**Proposal for amendments to ECE/TRANS/WP.29/GRVA/2020/32,
ECE/TRANS/WP.29/GRVA/2020/32 and comments on real world tests**

The experts from the European Commission would like to thank Germany for the two proposals to cover automated lane keeping systems above 60 km/h and automated lane changing functions. We welcome the objectives of these two proposals and would like to share the following general comments at this stage.

- **Par 5.2.3.3 ALKS 130.**

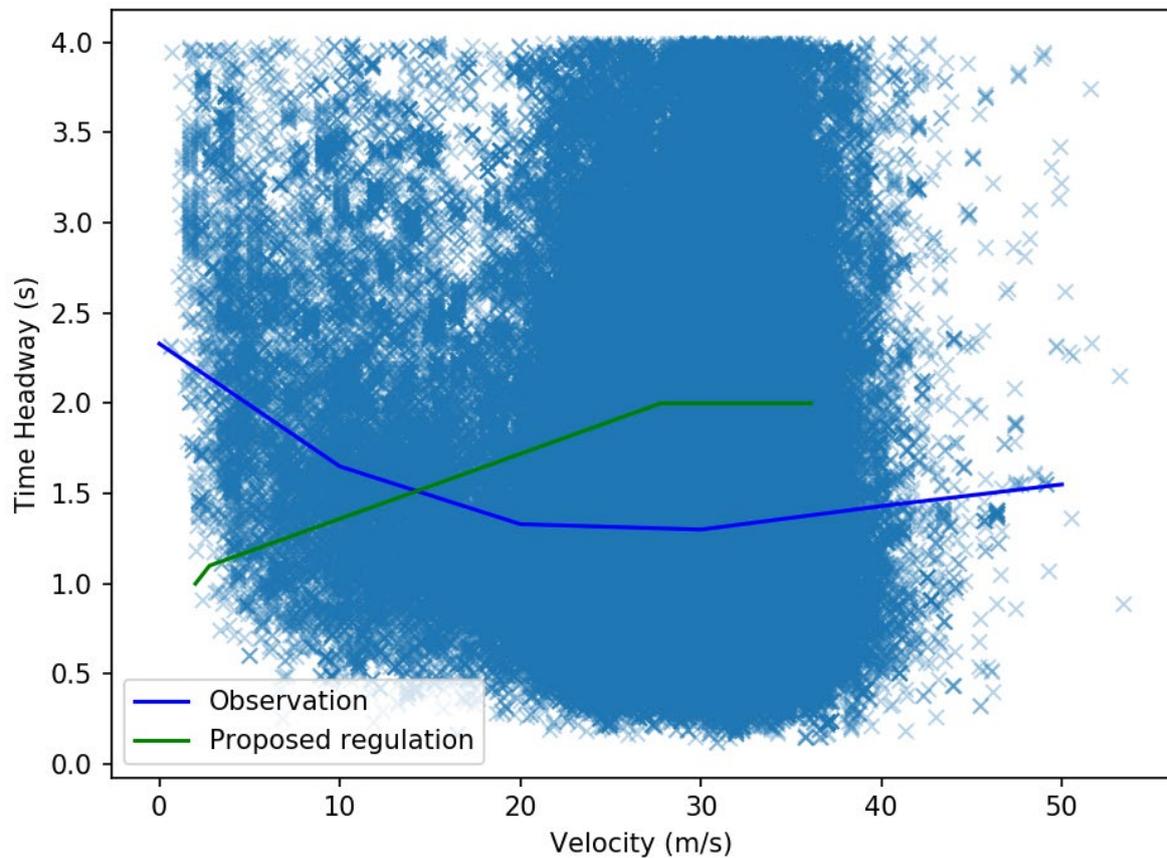
While it is obvious that with the increase in the speed the distance has to increase, it is not so obvious that also the time-gap has to increase. We therefore compared the relationship between speed and time-gap introduced by the amendment with what observed by human drivers (derived from the highD database of traffic data collected on German motorways).

The comparison is showed in the figure above in which the blue line is the median line from all the observations (represented by the blue dots) while the green line is the regulation requirement. The two lines show an opposite trend. It is worth noticing that the increase of the blue line in the right part of the diagram is due to the fact at high speed the vehicle is not always affected by the vehicle ahead. So this part of the diagram include cases in which the vehicle ahead is very far away ad this contributes to the new increase in the time-gap.

While AVs do not necessarily have to reproduce human behaviour, it would be important to understand the reason to chose those specific values.

We have also calculated the maximum theoretical road capacity generated by a traffic of ALKS130 vehicles fulfilling the aforementioned requirement. The maximum theoretical flow is almost 1950 veh/h which is not bad. The problem is that such a value is achieved for a speed of

40km/h and it drops to below 1700 veh/h for higher speed resulting in quite unnatural traffic behavior. Without proper traffic consideration the flow of AVs will generate a sensibly lower road capacity.
